Access Compliance Report Public Rights-of-Way (Curb Ramps)

Main Street: WINDMILL_AVE Cross Street: MAIN_ST Location: NW

ADA ID: RPRK211109114242 Ramp Type: Type 4 - Parallel Initial Pass/Fail: Fail Overall Compliance: No Severity Score: 16

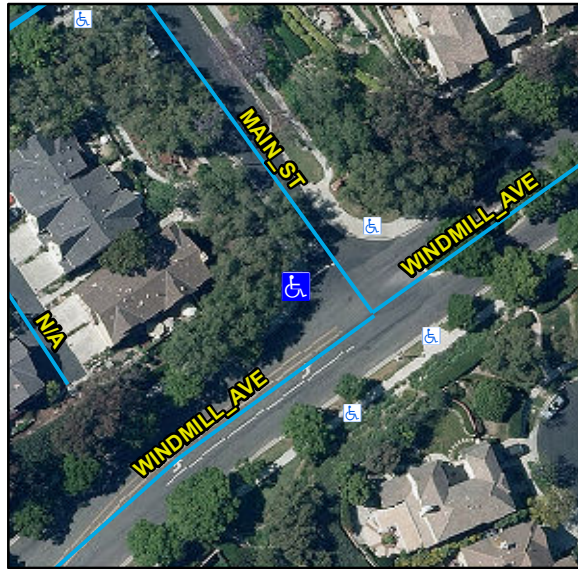
Compliance	Description	Data	Compliance	Description	Data
N/A	Ramp Length LT (in)	114	N/A	Ramp Length RT (in)	119
Yes	Ramp Width LT (in)	90	Yes	Ramp Width RT (in)	90
Yes	Ramp Run Slope LT (%)	4.8	No	Ramp Run Slope RT (%)	11.1
No	Ramp Cross Slope LT (%)	3.7	No	Ramp Cross Slope RT (%)	2.5
N/A	Landing Present	N/A	N/A	DWS Provided	N/A
N/A	Landing Length (in)	N/A	N/A	DWS Contrast	N/A
N/A	Landing Width (in)	N/A	N/A	DWS Length (in)	N/A
N/A	Landing Run Slope (%)	N/A	N/A	DWS Full Width	N/A
N/A	Landing Cross Slope (%)	N/A		DWS Offset Type	N/A
N/A	Landing Movement Obstructed?	N/A	N/A	DWS Offset Left (in)	N/A
	Landing Movement Type	N/A	N/A	DWS Offset Right (in)	N/A
N/A	Landing Shared	N/A			
N/A	Clear Space	Yes			
N/A	Clear Space To Crosswalk (in)	N/A			
N/A	Marked Crosswalk 1	No	N/A	Marked Crosswalk 2	No
	Crossing 1 Direction	S		Crossing 2 Direction	E
	Marked Crosswalk 1 Width (in)	N/A		Marked Crosswalk 2 Width (in)	N/A

N/A	Ramp Inside Crosswalk 1	N/A	N/A	Ramp Inside Crosswalk 2	N/A
	Crossing 1 Slope (%)	2.2		Crossing 2 Slope (%)	4.6
	Crossing 1 Cross Slope (%)	6.7		Crossing 2 Cross Slope (%)	2.1
N/A	Gutter Ponding	N/A	N/A	Curb Slope	10.8
Yes	Gutter Lip Height (in)	0		Road Run Slope (%)	7.1
N/A	Gutter Run Slope (%)	N/A		Road Cross Slope (%)	4
N/A	Gutter Cross Slope (%)	N/A	No	Perpendicular Joint Present	No
Yes	Overall Surface Condition	Acceptable			
	Cross Gutter Present?	No		Spandrel Present?	No
	Replace Cross Gutter?	N/A		Replace Spandrel?	N/A

Remove & Replace Curb Ramp With Two New Directional Ramps or Equivalent.

R204.3, R304.5.3, R304.3.2, STD 1115
